APPEAL	SUMMARY

Appeal ID: 20524	Project Address: 12031 SW Breyman Ave
Hearing Date: 6/12/19	Appellant Name: Marc Griffin
<b>Case No.:</b> B-017	Appellant Phone: 360-918-1146
Appeal Type: Building	Plans Examiner/Inspector: John Cooley
Project Type: residential	<b>Stories:</b> 2 <b>Occupancy:</b> Not given <b>Construction Type:</b> Not given
Building/Business Name:	Fire Sprinklers: No
Appeal Involves: Reconsideration of appeal	LUR or Permit Application No.: 19-143266-RS
Plan Submitted Option: pdf [File 1]	Proposed use: Single family dwelling

SOMERA RESIDENCE KITCHEN / BASEMENT REMODEL

12031 SW BREYMAN AVENUE PORTLAND, OREGON 97219

A402

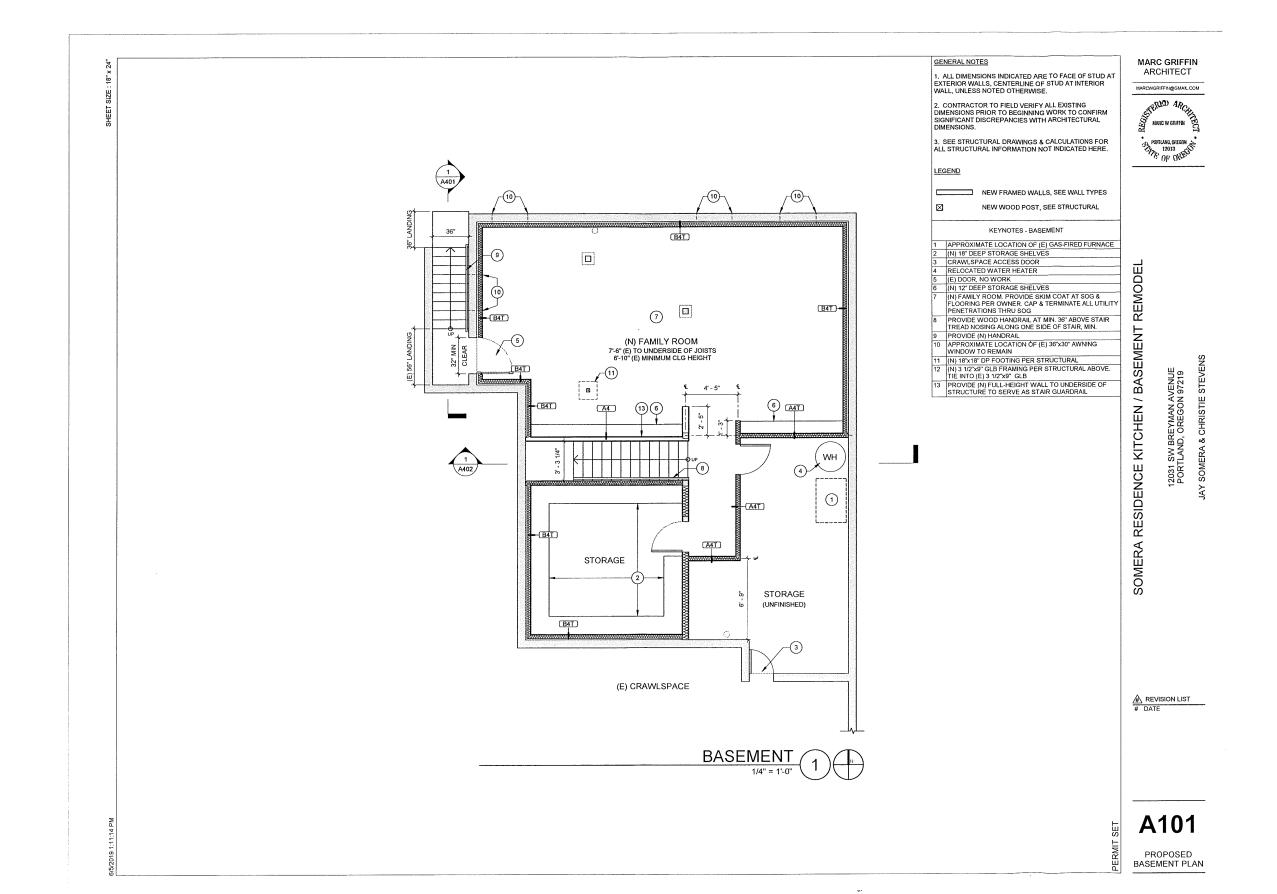
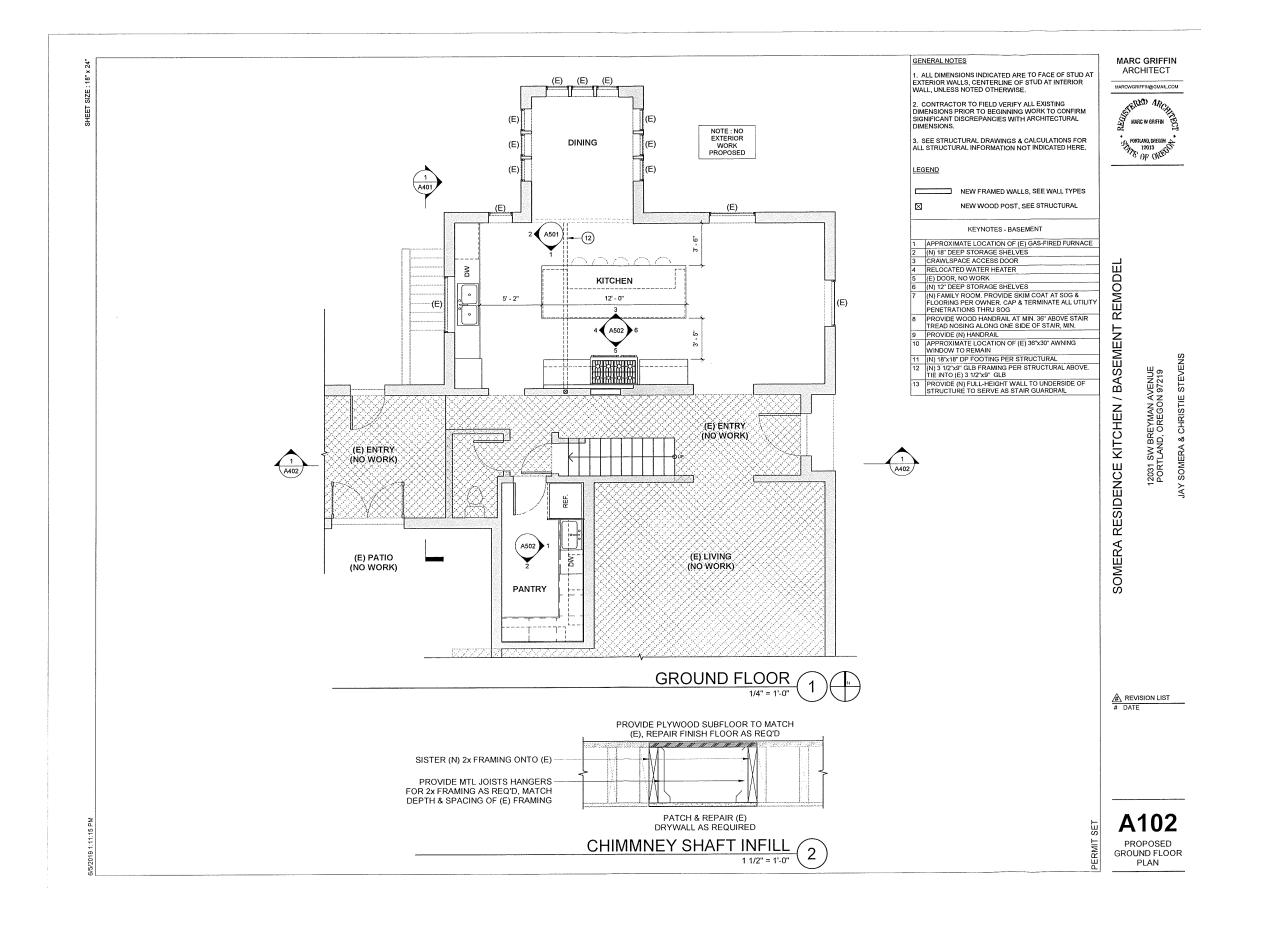
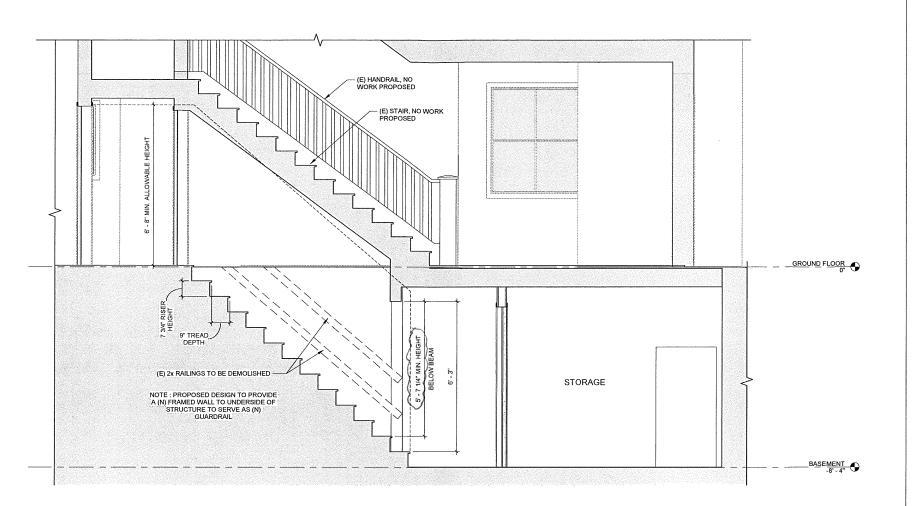
The existing noncompliant stair runs from the basement to the main level of the house. An existing stairway to the upper level is located directly above the basement stair. Reconstruction of the existing stair is not possible because of an existing door, the upper stair layout, and structural floor framing.

The is compliant with width & rise:run provisions, but cannot meet the clear headroom of 6'-8" required.

The proposed design is to bring the exterior stair into full compliance with the city of Portland code guide referenced on sheet A402 and to allow the existing stair to remain at a lower head height.

The original appeal was approved for the 6'3" Head Height but the plans that were submitted actually show a lower head height 5'7 1/4" however that dimension was not noted on the original appeal drawings and have now been added.

Additional to the language provided above, the existing stair and structural support systems for access to the upper floor infringe on the opportunity for a headroom compliant basement stair. If reconstruction of the basement stair is required the main to upper floor stair must also be rebuilt. The existing exterior stair is proposed to comply with all requirements of the city of Portland code guide referenced on sheet A402.

Reduction in minimum stair headroom to 5 feet 7 inches: Denied. Proposal does not provide equivalent Life Safety protection.
